UNITED STATES PATENT AND TRADEMARK OFFICE

APPLICATION NO.	FILING DATE	FIRST NAMED INVENTOR	ATTORNEY DOCKET NO.	CONFIRMATION NO.
10/537,390	01/31/2007	Adrian Kendall	35832.000118	7962
64770 7590 05/30/2008 Momkus McCluskey, LLC 3051 Oak Grove Road Suite # 220 Downers Grove, IL 60515-1181				
EXAMINER				
DOAN, JENNIFER				
ART UNIT		PAPER NUMBER		
2874				
MAIL DATE		DELIVERY MODE		
05/30/2008		PAPER

Office Action Summary

DETAILED ACTION

FIG. 4A

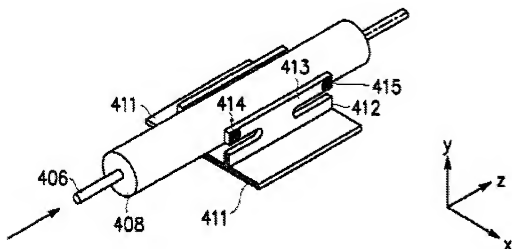
With respect to claim 1, Kwon et al. (figure 4A) disclose an apparatus for aligning and fixing an optical fibre relative to an optical source, comprising first and second fixing brackets, each fixing bracket including a support member (412) for attachment to a substrate; first and second cantilever arms extending from the support member (412) in opposing directions, each cantilever arm including fibre engagement means (414, 415) for engaging with the optical fibre (406); the apparatus further comprising a substrate (11) (column 6, lines 22-23) including support means for receiving the support members (412) so as to dispose the first and second fixing brackets such that the fibre engagement means (414, 415) of the first fixing bracket oppose the fibre engagement means of the second fixing bracket (see figure 4A), for receiving and supporting an optical fibre therebetween at two longitudinal positions of the optical fibre (406) (see figure 4A).

With respect to claim 2, Kwon et al. (figure 4A) disclose the apparatus, in which the first and second cantilever arms are of unequal length (see figure 4A).

With respect to claim 6, Kwon et al. (figure 4A) disclose the apparatus in which the cantilever arms have a rectangular cross-section (see figure 4A).

With respect to claims 7-9, Kwon et al. disclose apparatus, in which at least one of the cantilever arms has varying cross-sectional area along its length; wherein the at least one cantilever arm has a tapering cross-sectional area along its length and at least one cantilever arm has a step change in cross-sectional area along its length (see figures 4A and 4B).

With respect to claim 10, Kwon et al. (figure 4A) disclose the apparatus of claim 1 in which the support members each comprise a channel running therethrough (see figure 4A).

With respect to claim 11, Kwon et al. (figure 4A) disclose the apparatus in which the channel runs substantially orthogonal to an axis extending between the fibre engagement means (414, 415, see figure 4A).

With respect to claim 16, Kwon et al. (figure 4A) disclose the apparatus, further including an optical fibre (406) positioned between and supported by the fibre engagement means.

With respect to claim 17, Kwon et al. (figure 4A) disclose the apparatus, further the optical fibre (406) is coupled to an engagement surface of each of the respective fibre engagement means by way of a spot weld (column 3, lines 57-61).

With respect to claim 18, Kwon et al. (figure 4A) disclose the apparatus, in which the optical fibre (406) includes a sleeve encasing an optical carrier.

With respect to claim 32, Kwon et al. disclose (figure 4A) a method for aligning and fixing an optical fibre relative to an optical source comprising the steps of positioning first and second fixing brackets on a substrate (11) such that first and second fibre engagement means (414, 415) of the first fixing bracket oppose first and second fibre engagement means of the second fixing bracket (figure 4A); positioning an optical fibre (406) intermediate the first and second fixing brackets for support therebetween at two longitudinal positions of the fibre; securing the first and second fixing brackets to the optical fibre (406) at the points of contact of the fibre engagement means (414, 415) to the fibre; and adjusting the fibre alignment relative to the optical source (column 2, lines 46-48).

With respect to claim 33, Kwon et al. disclose (figure 4A) disclose the method, further including the steps of, after positioning the optical fibre, aligning the fibre to the optical source (column 2, lines 46-48) securing the first and second fixing brackets to support means included on the substrate (11).
